**Comments of the Natural Resources Defense Council (NRDC) on the 2011 IEPR –  
*Electricity, Natural Gas, and Transportation Energy Preliminary Forecast***

Docket Numbers 11-IEP-1C, 11-IEP-1K, 11-IEP-1L

March 07, 2011

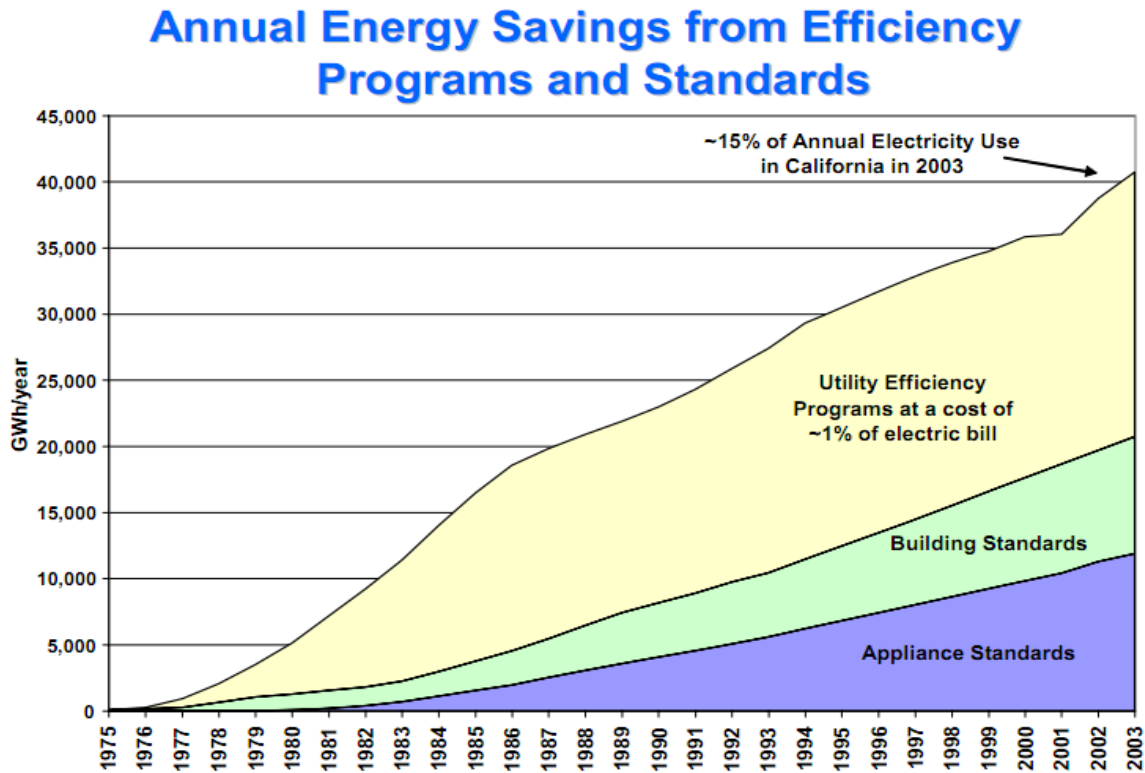
The CEC has published estimates of the cumulative impact of energy efficiency programs and codes and standards over the years. For example, in both the Energy Action Plan II of 2005, and the CEC Loading Order Staff Paper<sup>2</sup>, the CEC published the following

graph.<sup>3</sup>

**Figure 159: Distribution of Efficiency/Conservation Consumption Savings by Source**

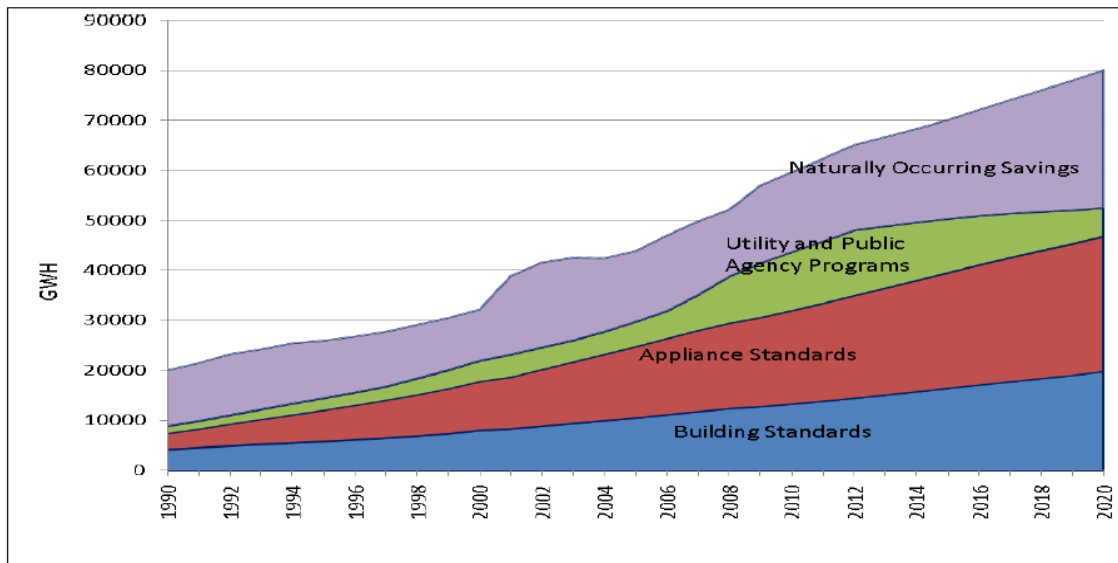
However, in the 2009 IEPR Demand Forecast, the CEC published the following graph that dramatically changed the picture:

The CEC's 2009 graph reduces the cumulative savings attributed to utility programs **by over 75%.**<sup>4</sup> In some historical years, the savings attributed to utility programs were reduced by 92% (i.e., the CEC only used 8% of the savings that were reported in those years).<sup>5</sup> These extreme reductions were made without an adequate public process before the CEC, conducted in the absence of any evaluation studies by or on behalf of the CEC, incommensurate with CPUC evaluations of historical savings, and incommensurate with similar estimates of efficiency in similar neighboring regions. For these reasons, among others,<sup>6</sup> it would be unreasonable if the CEC were to adopt these drastic reductions of savings attributed to utility programs.

**4. We recommend that the 2011 IEPR retract the graph attributing historical energy savings to various policies and sources that was presented in the 2009 IEPR since the depiction of savings from utility programs was inaccurate.**

In addition to the technical reasons why the 2009 graph should be retracted, there are significant policy concerns about such a portrayal of energy savings. If policymakers were to erroneously conclude based on the 2009 IEPR graph that efficiency programs have had little effect and that savings would have largely occurred without programs to overcome market barriers, it could severely undermine the state's commitment to energy efficiency. NRDC recommends that the CEC retract the graph of historical energy savings attributed to various policies and sources, from the 2009 IEPR.

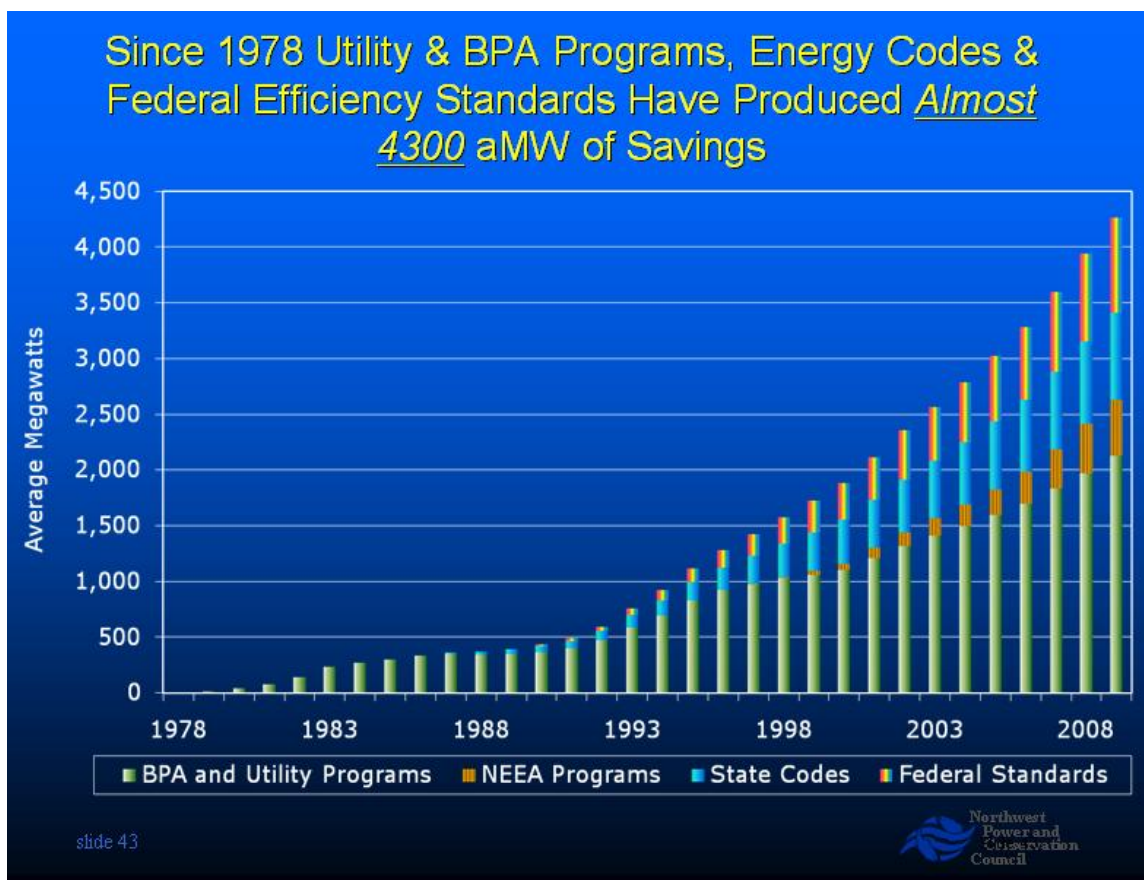
Furthermore, these newer CEC estimates are incommensurate with how our neighbors in the Pacific Northwest estimate savings from efficiency programs, which are similar to those in California<sup>8</sup>:

Similar to how savings were assessed among programs and codes and standards historically by the CEC (e.g. in the 2005 Energy Action Plan II), the Northwest Power and Conservation Council (NWPCC) estimates cumulative savings from both utility programs and codes & standards. The Northwest efficiency program administrators have been running programs since the 1970s, like California, and have been running programs similar in nature to those of California. The NWPCC estimates about half of the energy savings are attributed to utility programs, similar to the CEC's findings prior to the 2009 IEPR. The NWPCC estimate is commensurate with how savings were attributed in the 2005 Energy Action Plan II. However, the CEC's Preliminary Forecast proposes to use drastically lower values, as described above, which are incommensurate with how our neighboring region estimates efficiency. We recommend that the CEC consult with the NWPCC to compare methodologies and assumptions to better understand how program

savings are accounted for and to develop an improved methodology to track California's historical efficiency savings from various sources.
